SERVICE BULLETIN

M-860

SERVICE INFORMATION — XL MODELS

Figure 1. Cylinder Head Gasket Surface

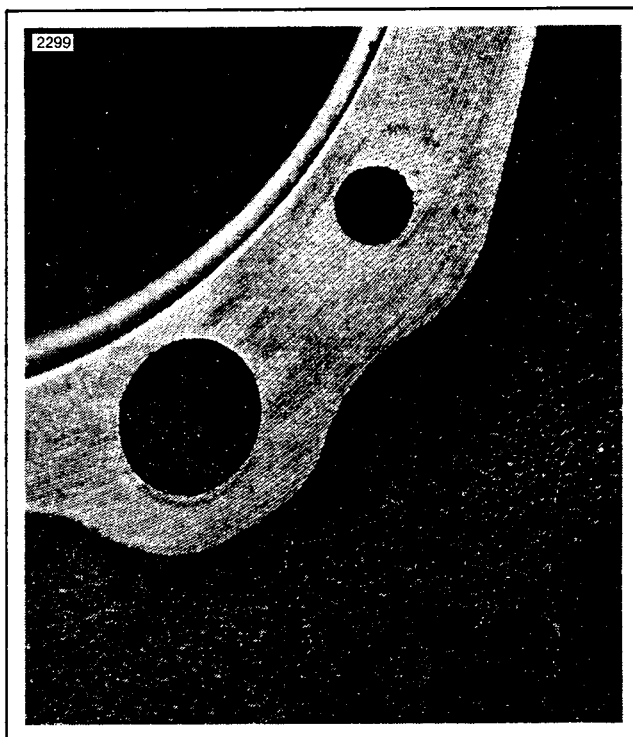
See Figure 1. The gasket surface of cylinders and cylinder heads has been improved with a new finish implemented in production. The finish has an appearance similar to grooves of a phonograph record. The soft copper head gasket conforms to the finish and prevents oil

leakage at the oil return passages. Cylinder head bolt torque is unchanged (55-65 ft-lbs).

Figure 2. Gerotor Oil Pump

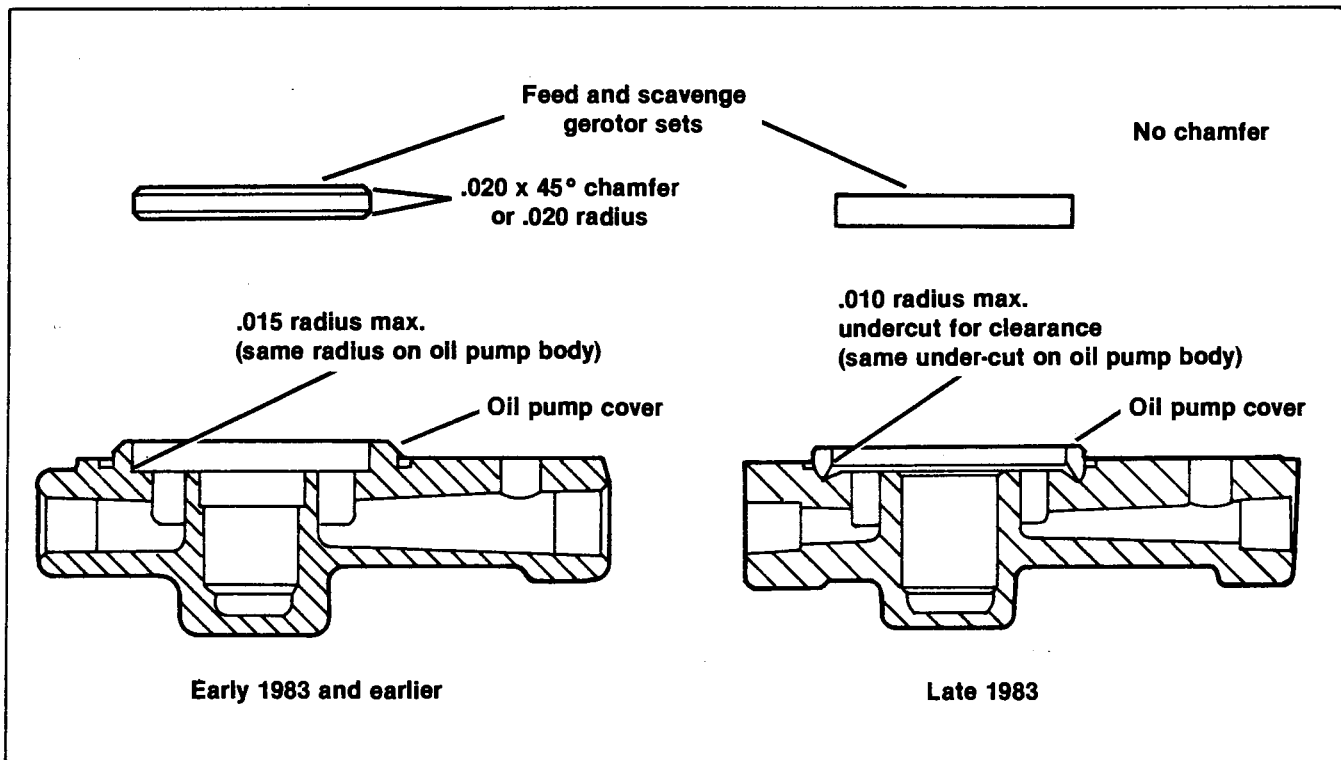
See Figure 2. Early 1983 and earlier gerotor pump gears had chamfered outer edges. Late 1983 oil pump assemblies contain different gerotor gears that do not have chamfered top and bottom outer diameters. Late 1983 pump bodies and covers have an under-cut or relief as shown to provide the necessary clearances.

These modifications limit interchangeability to the following:

1. Either early style or late style gerotor gears may be used with late style (under-cut) oil pump bodies and covers.
2. Only early style chamfered gerotor gears may be used with early style oil pump bodies and covers.

Use of late style gerotor gears in early style oil pump

bodies and covers could cause the oil pump to bind.

Figure 3. Fabricating and Using Jumper Cables —
1983 XL Models

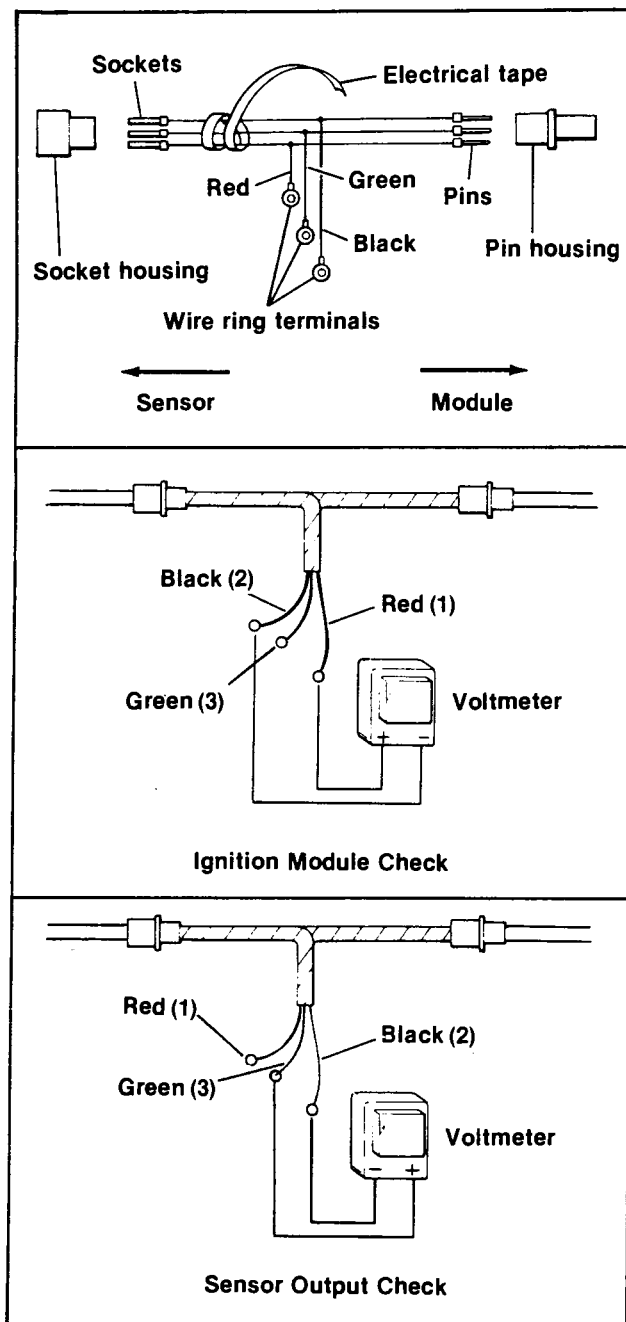
Ignition module plugs are new to prevent intermixing of 1983 ignition components with earlier Magnavox modules and sensors.

See Figure 3. To perform module and sensor checks of 1983 components fabricate a jumper cable as shown. The parts needed are:
